SERVICE BULLETIN

SB-AG-90

DUMP HANDLE CALIBRATOR MODIFICATION

Affected Aircraft Models	Serial Number Range
S2R	ALL DUAL COCKPIT/DUAL CONTROL OPTIONAL SINGLE CONTROL

Figure 1

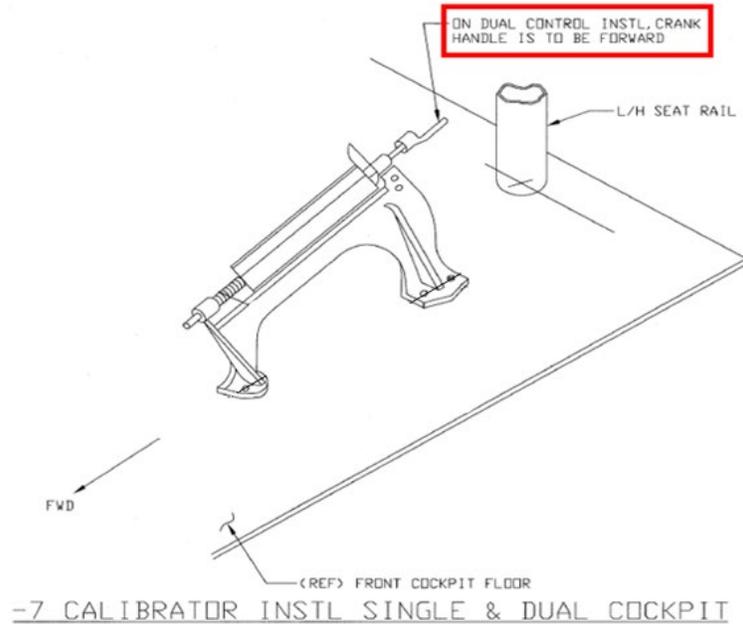
1. For Single Cockpit and Dual Cockpit/Single Control configuration aircraft, it is standard to install the Dump Handle Calibrator Crank facing aft (upward) as shown in Figure 1.

Figure 2

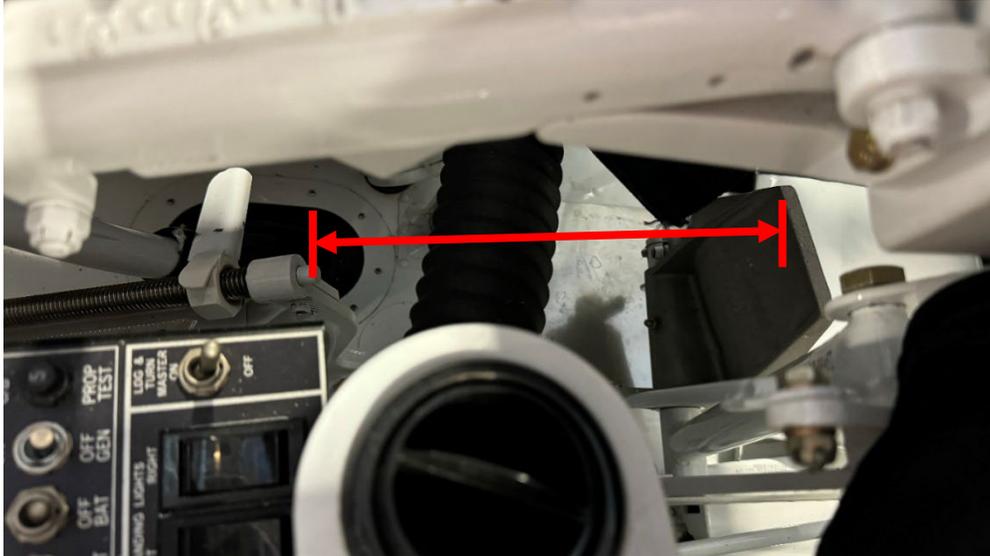
2. For the Dual Cockpit/Dual Control configuration aircraft Thrush installed the Dump Handle Calibrator Crank facing forward (downward) as shown in Figure 2 to avoid interference with the full range of movement of the aft left-hand rudder pedal (reference Figure 3).

Figure 4

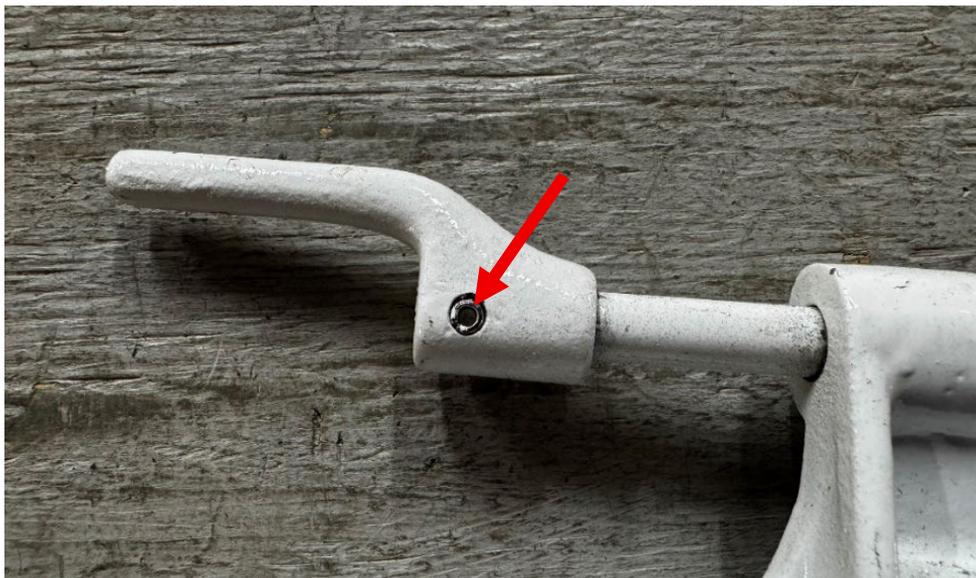
1. Remove the Dump Handle Calibrator from the cockpit and place on a work surface.
2. Remove the existing Crank Handle from the spindle shaft by removing the spring pin and set aside if it not damaged. (Reference Figure 4)

Figure 5

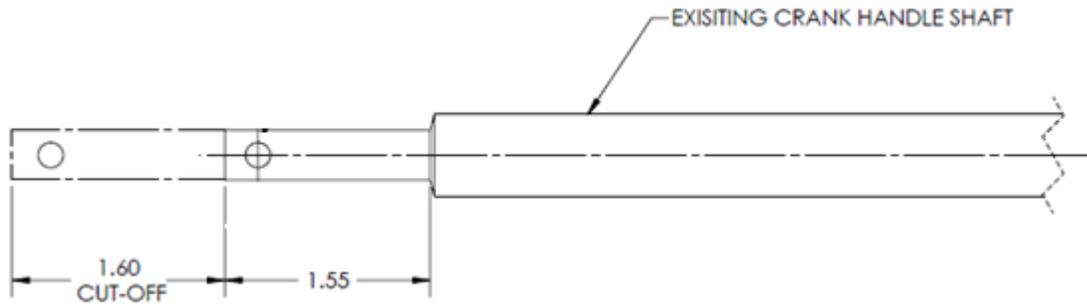
1. Cut or remove 1.60" (40.64 mm) from the spindle shaft. (Reference Figure 5)
2. Install knob on spindle shaft.
3. Match drill .1875" Ø thru spindle shaft.
